Access Compliance Report

Public Rights-of-Way

(Curb Ramps)

Intersection ID: 47573	Main Street: SEDGEBURN_DR	Cross Street: GAILES_DR	Location: NE
ADA ID: 164B1958E74D	Ramp Type: PerpDiag	Initial Pass/Fail: Fail	Overall Compliance: No
Severity Score: 22.5			
Codes/Mitigation Info/Possible Solution		Field Measurements/Component Compliance

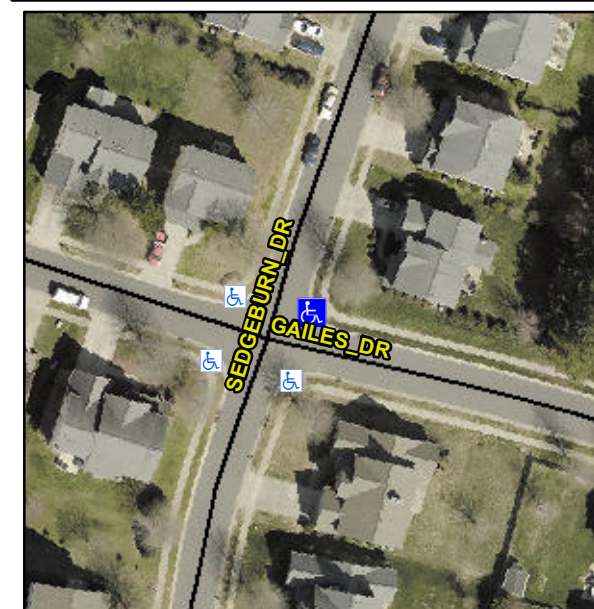
R304.5.1, R304.2.2, R304.5.3

Compliance	Description	Data	Compliance	Description	Data
N/A	Ramp Length (in)	46.0	No	Ramp Slope (%)	9.0
No	Ramp Width (in)	47.5	No	Ramp XSlope (%)	4.9
N/A	Flare Type LT	N/A	N/A	Flare Type RT	N/A
N/A	Flare Slope LT (%)	N/A	N/A	Flare Slope RT (%)	N/A
N/A	Flare Traversable LT?	N/A	N/A	Flare Traversable RT?	N/A
N/A	Landing Length (in)	N/A	N/A	DWS Provided?	N/A
N/A	Landing Width (in)	N/A	N/A	DWS Contrast?	N/A
N/A	Landing Slope (%)	N/A	N/A	DWS Length (in)	N/A
N/A	Landing X Slope (%)	N/A	N/A	DWS Full Width?	N/A
N/A	Landing Curb? (Y/N)	N/A	N/A	DWS Offset (in)	N/A
N/A	Shared Landing?	N/A			
N/A	Gutter Ponding?	N/A	N/A	Gutter Slope (%)	N/A
N/A	Gutter Lip Ht (in)	N/A	N/A	Gutter X Slope (%)	N/A
N/A	Painted X Walk1?	No	N/A	Painted X Walk2?	No
	X Walk 1 Direction	To NW		X Walk 2 Direction	To SW
N/A	X Walk 1 Width (in)	N/A	N/A	X Walk 2 Width (in)	N/A
	X Walk 1 Slope (%)	4.9		X Walk 2 Slope (%)	2.4
	X Walk 1 X Slope (%)	1.1		X Walk 2 X Slope (%)	3.1

N/A	Ramp inside XWalk1?	N/A	N/A	Ramp inside XWalk2?	N/A
	Road Slope (%)	4.5	N/A	Clear Space?	N/A
	Road X Slope (%)	1.3	N/A	Clear Space to XWalk (in)	N/A
N/A	Any Obstructions?	N/A	N/A	Storm Grate/Utility Hazard?	N/A
	Obstruction Type			Storm Grate/Utility Type	
		N/A			N/A
			Yes	Surface Condition? (G/P)	Good

Remove & Replace Curb Ramp With Two New Directional Ramps or Equivalent.
